**STAFF REPORT**  
(Final Plat, Preliminary Plat Approved 3/6/97)

**CASE NUMBER:** S/D 97-16 - CEDAR RIDGE MOBILE HOME PARK

**STAFF REPORT**  
**(Preliminary Plat)**

**CASE NUMBER:** S/D 97-16 - CEDAR RIDGE MOBILE HOME PARK

**VICINITY MAP:**

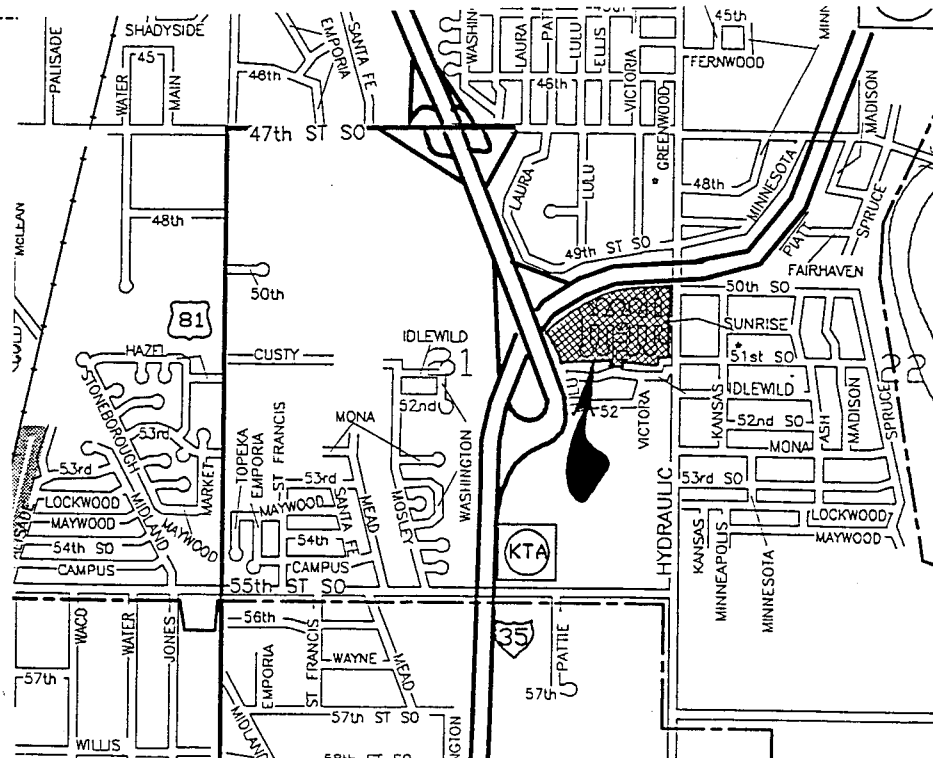
- D. In regards to this Reserve A, a covenant shall be provided to allow the City the authority to maintain any drainage purpose associated with this Reserve and to charge back to the property owner, any related costs by a method similar to special assessments.

- E. The applicant is advised that the City's Code on mobile home parks require that eight (8) percent of a site be set aside for "useable" open space, for use by the Addition's residents. The drainage function associated with Reserve A, with the limited bank area around the water area is of questionable open space use. The site plan is subject to review and approval by the Director of Planning and if found necessary, is subject to change.

- F. On the final plat tracing, Lot 2, Block 1's boundary (lot lines) shall be shown at the same weight line as used for Lot 1. That is, Lot 2 shall be depicted in the same manner as the other portion(s) of the plat.

- G. On the final plat tracing, additional wording needs to be added to the platter's text in regard to the emergency access easement. Specifically, it needs to be indicated that this

easement cannot be encumbered at any time, except that any improvements (driving surface, gates, etc.) will be to the standards determined by the City's Fire Department.

- H. On the final plat tracing, the County Clerk's signature shall be corrected to read James Alford.
- I. The applicant shall install or guarantee the installation of all utilities and facilities which are applicable and described in Article 8 of the MAPC Subdivision Regulations. (Water service and fire hydrants required by Article 8 for fire protection shall be as per the direction and approval of the Chief of the Fire Department.)

**VICINITY MAP:**

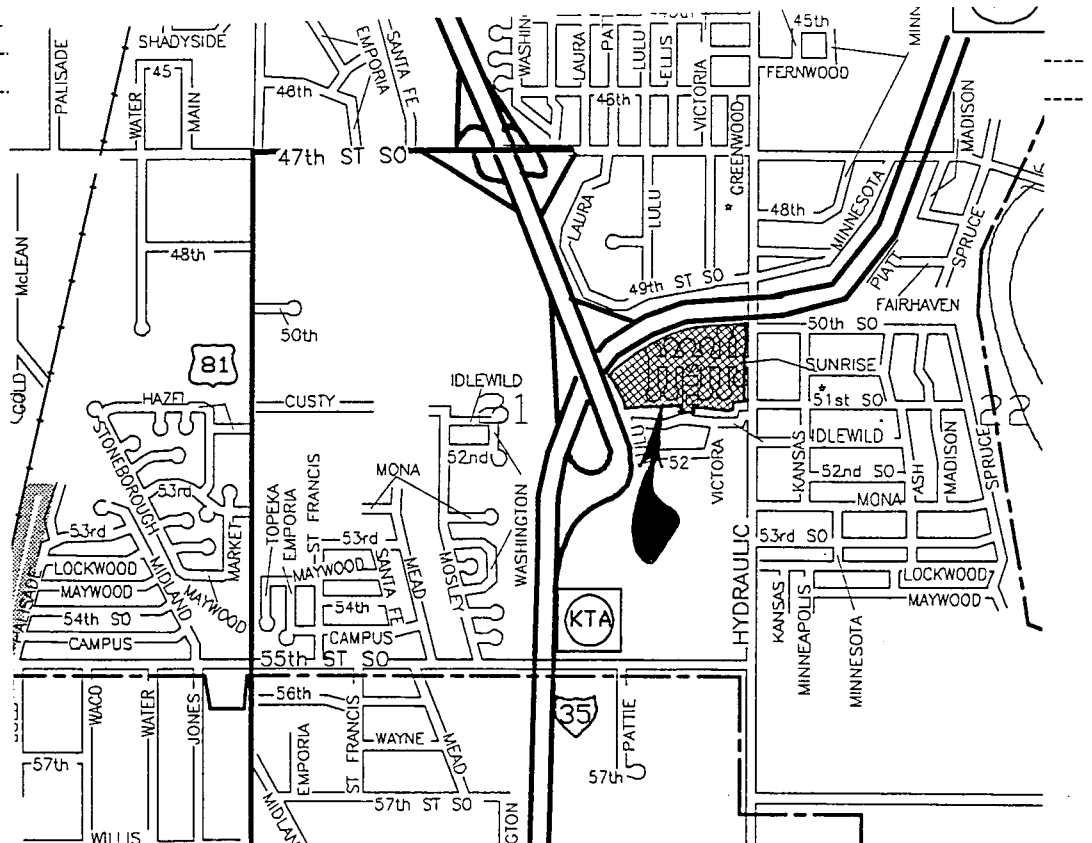
- D. On the final plat, the access controls to Hydraulic shall remove the word "complete" from the face of the plat. Since an opening is being shown for these areas, the word complete is contradictory.

- E. On the final, the half street right-of-way (50 foot) for Hydraulic adjacent to this plat shall be clearly depicted.
- F. On the final plat, the uses of Reserve A shall be noted in the plat's text. Also, it shall be indicated that the Reserve will be owned and maintained by the owner of Lot 1, Block 1 of this Addition.

In regards to this Reserve A, **City Engineering** needs to indicate if a covenant should be provided to allow the City, the authority to maintain any drainage purpose associated with this Reserve and to charge back to the property owner, any related costs by a method similar to special assessments.
- G. On the final plat, the designation of "Block 1" shall also be placed in the area of Lot 1.
- H. The applicant is advised that the City's Code on mobile home parks require that eight (8) percent of a site be set aside for "useable" open space, for use by the Addition's residents. The drainage function associated with Reserve A, with the limited bank area around the water area is of questionable open space use. The site plan is subject to review and approval by the Director of Planning and if found necessary, is subject to change.
